THIS DRAWING MUST NOT BE LOANED OR COPIED WITHOUT PERMISSION OF ION TRACK INSTRUMENTS LLC. UNLESS OTHERWISE SPECIFIED DIM ARE INCHES (MILLIMETERS) TOL ON ANGLE ±.5° 2 PL ±.01 (0.25) 3 PL ±.005 (0.13) SURFACE ROUGHNESS 32μIN (0.80μM) INTERPRET DIM AND TOL PER ASME Y14.5M-1994		MATERIAL		<div> 205 Lowell Street Wilmington MA 01887-2941 978-658-3767</div>			
		FINISH					
THIRD ANGLE PROJECTION		APPROVALS		DATE		TITLE	
		DRAWN BY: JDN		11/13/2000		OVERALL DIMENSIONS, HOUSING, ITEMISER 3, P0007018	
		MFG ENGR:					
		PROJ ENGR:					
		SIZE D		CAGE CODE 55503		DWG NO MP022262	
		SCALE 1:1				REV B	
						SHEET 1 OF 1

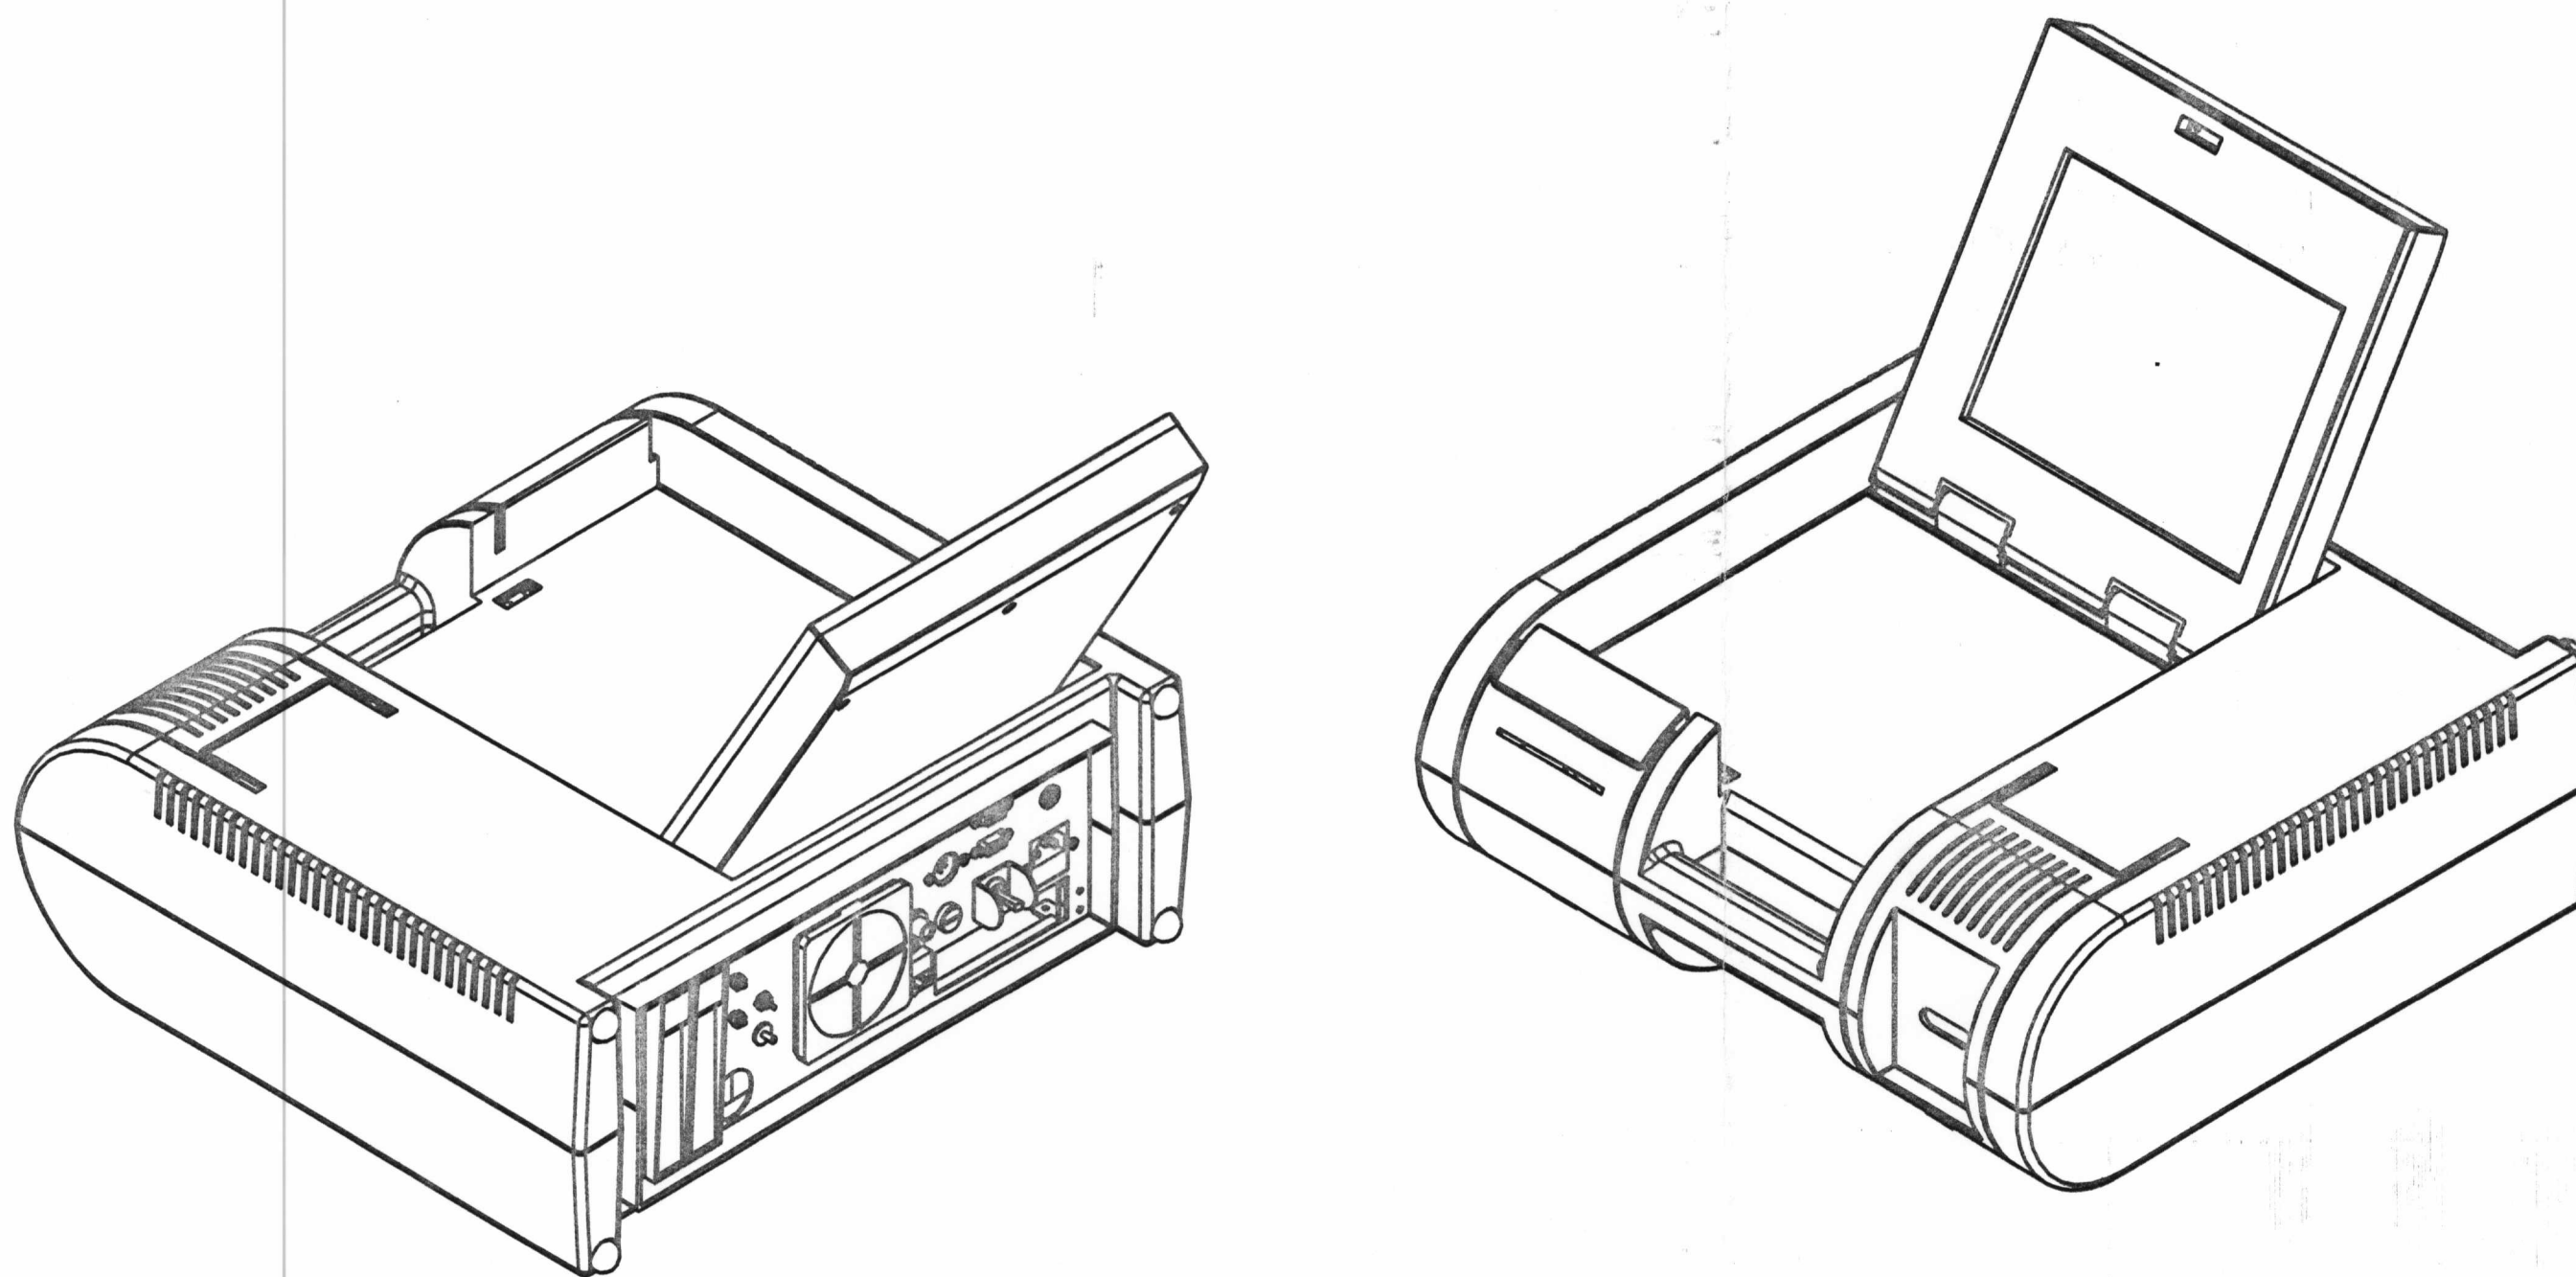
REVISION HISTORY				
REV	ECO	DESCRIPTION	DATE	APP'D
A		INITIAL DRAFT	11/13/2000	J. NAPOU
B		Ⓢ DIM WAS 14.88 Ⓢ DIM WAS 16.25	11/07/2001	J. NAPOU

14.94(380[Ⓢ]mm)
(16.31[414mm] VERT. POSITION[Ⓢ])
